Product Change Notification

| Date Issued : | July 14, 2022 | PCN Number : | 512266 |
| Reason for Change : | Change to Product Packaging Method/Quantity Changing | | |

- 98817 Series
- NSCC Rcpt Hsg 1.5 2Ckt

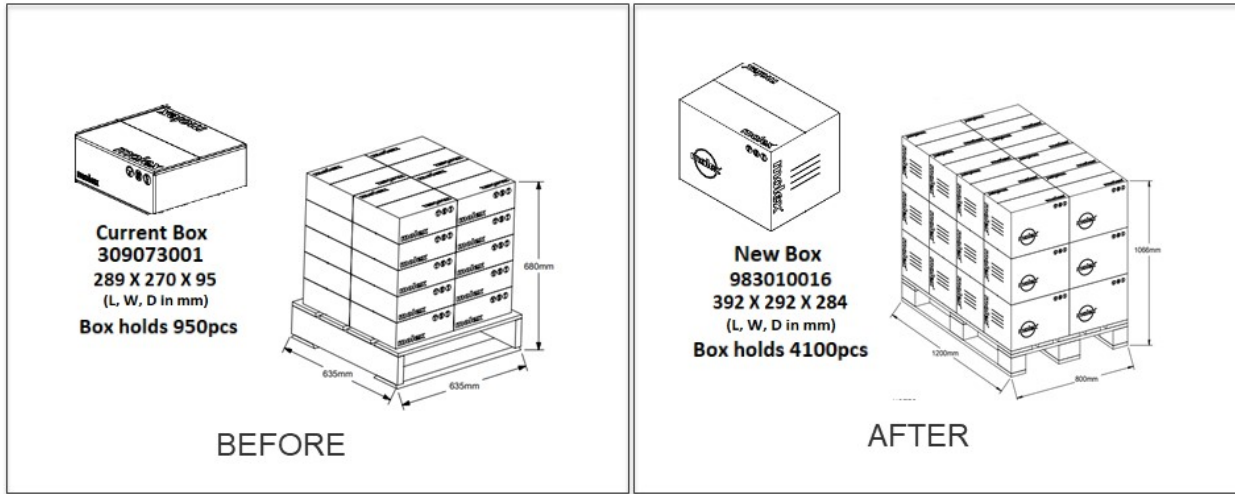
- To ensure latch robustness during transport, product design is changing
 - Protective walls are being added on either side of the latch
 - Packaging and Delivery unit will change during this time to match standard boxes used on other circuit sizes
- There is NO impact to Fit or Function
 - Protective walls will affect the Form and Appearance of the product
- Samples and Qualification reports available upon request after dates shown above
- Part Numbers Impacted
 - See attached list
